UNITED STATES PATENT AND TRADEMARK OFFICE

APPLICATION NO.	FILING DATE	FIRST NAMED INVENTOR	ATTORNEY DOCKET NO.	CONFIRMATION NO.
09/800,006	03/06/2001	James C. Rush	STE01 P-1086	5256

Office Action Summary

DETAILED ACTION

FIG. 14E

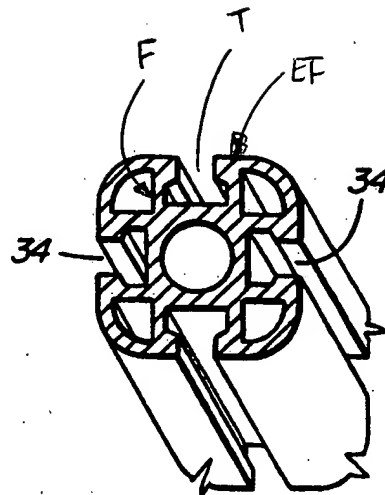
of the open office space in a laterally spaced apart relationship, and an upper portion thereof operably connected with the opposite ends of said overhead beams (10) to support said beams (10) at a predetermined elevation above average user height; at least one of said posts having an X-shaped plan (see figure 14E) configuration defining four mutually perpendicular, outwardly extending flanges (F), each of which has an end face (EF) with a single T-shaped vertical slot (T) extending centrally therealong; at least one of said posts (12) having a Y-shaped plan configuration (see figure 14D) defining three regularly spaced apart, outwardly extending flanges (F2), each of which has an end face (EF2) with a single T-shaped vertical slot (T2) extending centrally therealong (Column 8, lines 57-65); and a plurality of beam-to-post connectors (14,50) attached to the opposite ends of said beams, and detachably retained in said slot (T,T2) of aligned pairs of said flanges (F,F2) on said posts (12) to support said beams (10) on said posts (12) at said predetermined elevation, see the marked attachment. The at least one of said beam-to-post connectors (14,50) of DWILLIES further includes an outwardly projecting stop (14,52) which abuts an uppermost end of an adjacent one of said posts (12) to locate and positively retain an associated one of said beams (10) at said predetermined elevation and also includes at least one partition accessory (20) configured to equip said furniture system for users, and having a mount portion (being the edges of the panel thereof) detachably retained in said slot (22) of one of said posts (12). In reference to claim 81, one of said beams (10) includes opposite side faces, each of which includes a T-shaped hanger slot (22) extending longitudinally therealong; wherein the T-slots (22) are sized and shaped to receive the mount portions (being the
